SERVICE BULLETIN SB01.01

Machines/Models: SB60**Serial Numbers:** 1102-1408

PURPOSE: Lower Generator Option Case Pressure by Installing a Case Drain Line.

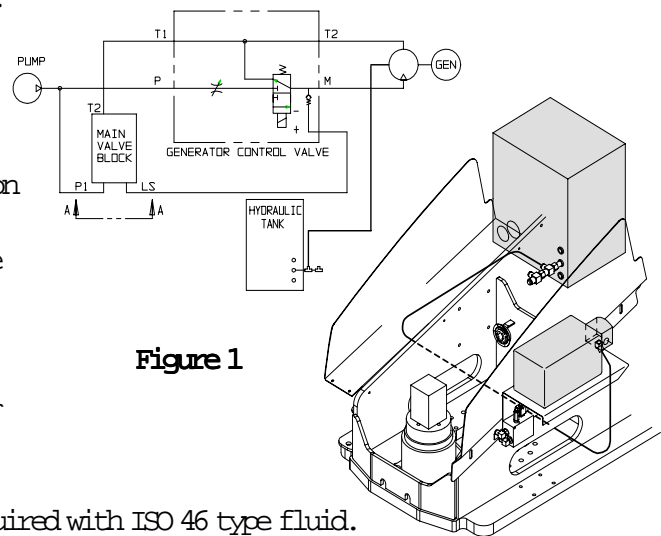
PROCEDURE REQUIRED: Install a Case Drain Return Line to the Hydraulic Tank.

1. Remove hydraulic motor case drain plug on bottom of hydraulic motor and install 45 degree-#4 fitting (A small amount of fluid will drain from case this is normal).

2. Connect the supplied hose to the newly installed case drain fitting and torque to 135 in. lbs.
3. Route hose to the tank per Figure 1.
4. Drain Hydraulic tank to below the middle return port.

5. Disconnect the existing tee or hose (dependent on serial number of the machine) from the middle return port on the hydraulic tank.
6. Install the supplied tee to the middle return boss of the hydraulic tank.

7. Install the removed tee or hose (dependent on serial number of the machine) to the newly installed tee per Figure 1 and torque all fittings to 135 in. lbs.
